IMPORTANT SAFETY NOTICE

Subject: All RIDGID® Models 122 and 122XL Copper Cutting/Prep Machines Manufactured from December 2020 to May 2022

August 1st, 2022

Figure 4: Example of affected unit without 90° motor strain relief present

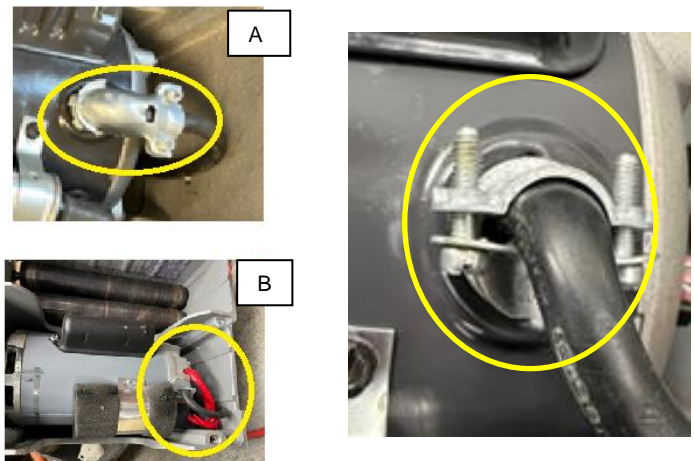
This is a Product Safety Notice. The Ridge Tool Company recently determined that excessive vibration from transportation could potentially fray the motor wire in the 122/122XL Copper Cutting/Prep Machines which may cause wire damage that could result in injury from electric shock.

All 122/122XL Copper Cutting/Prep Machines produced between December 2020 to May 2022 are potentially affected by this issue including both 115V and 220V models. Affected units can be identified by the machine date code on the serial plate (Figure 2) and by turning the machine on its side and looking through the motor cover for the presence of either a 90° motor strain relief or red colored motor wires (Figure 3).

If **neither** the 90° motor strain relief **nor** red motor wires are present (Figure 3 compared to Figure 4) **and** the machine has a date code between 1220 and 0522, the machine **is affected** by this Safety Notice and the motor strain relief must be changed by RIDGID Technical Services to a 90° motor strain relief. **Do not use affected 122/122XL Copper Cutting/Prep Machine until reworked by RIDGID with the proper 90° motor strain relief.**

Do not use affected 122/122XL Copper Cutting/Prep Machine until reworked by RIDGID with the proper 90° motor strain relief. Contact RIDGID Technical Services at 888-743-4333 or RTTechservices@emerson.com to arrange for rework at no charge to you. Thank you for your cooperation and we regret any inconvenience that this may have caused you. If you have any questions, please contact RIDGID Technical Services.
